REF. CK-359 (RFA-1 Schematic)

REQ. ITEM	PART NO.	DESCRIPTION	SYMBOL
STOCK SIZE		THE TECHNICAL MATERIEL CORP. MAMARONECK, NEW YORK	
MATERIAL	WEIGHT PER PC.	SCHEMATIC DIAGRAM	
TYPE & TEMPER		PSP-350	
HEAT TREAT. SPEC.		16 5/2/58 DRAWN ELEC. DES. APP. MECH. DES. APP.	
FINISH & SPEC. NO.		CHECKED FINAL APPROVAL

CK-358 F

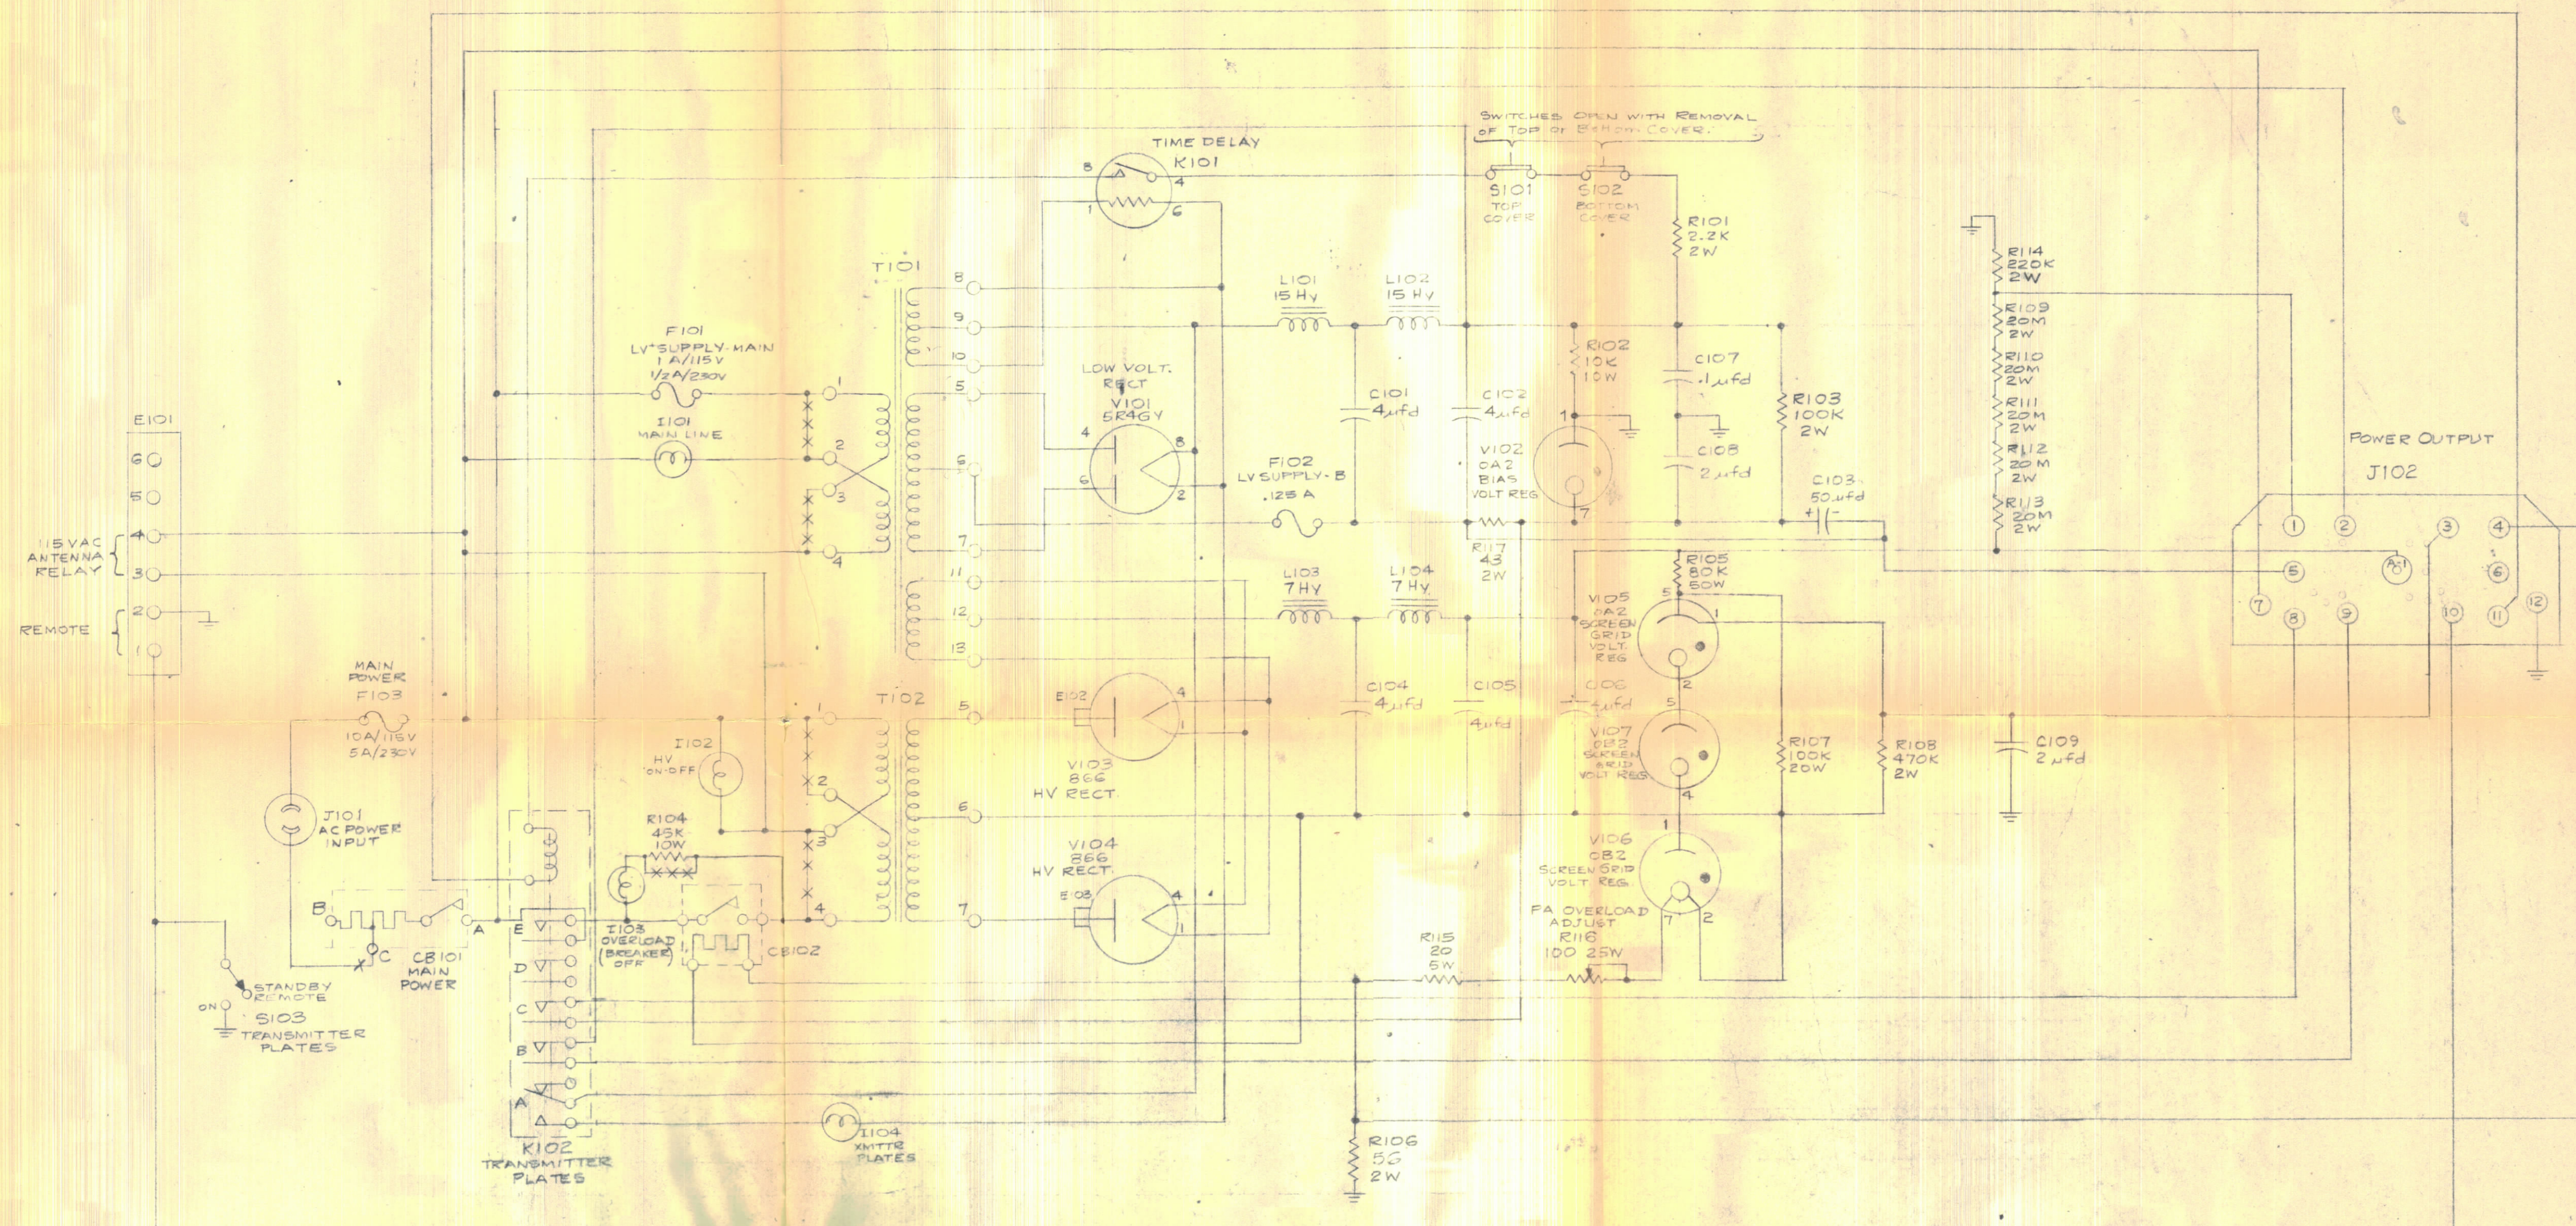
CHANGES NECESSARY TO CONVERT TO 230 V OPERATION.

T101 Remove Jumper marked XXX and connect jumper between terminals #2 & 3.

T102 Same as T101

CB101 Remove lead from terminal "C" and connect it to terminal "B".

R104 Remove and discard jumper marked XXX

F101 Change from 1 amp to 1/2 amp

F103 Change from 10 amp to 5 amp

ISSUE	ITEM	CHANGED FROM	DATE	CN. NO.	DRAFTS	CHECKER	ENG. APP.
F	1	CB101 Term "E" WAS "C". "C" WAS "B" (SEE NOTE) R104 WAS 10K	7/10/58	413	16	W.D. AST	
E	1	L103, L104 CHD FROM 10H V. TO 7H V.	7/21/58	403	16	W.D. AST	
D	1	R117 CHD FROM 5K TO 4.3K	4/14/58	395	16	W.D. AST	
C	1	R102 WAS 100K, 2W NOW IS 50K, 2W	4/14/58	3	16	W.D. AST	
B	1	C109 ADDED	4/14/58	2	16	W.D. AST	
A	3	R117 ADDED C103 ADDED LEAD ADDED FROM R117 TO C103 C105A, B, C, D C107 WAS C105A, C105B, C105C	5/17/58	1	16	W.D. AST
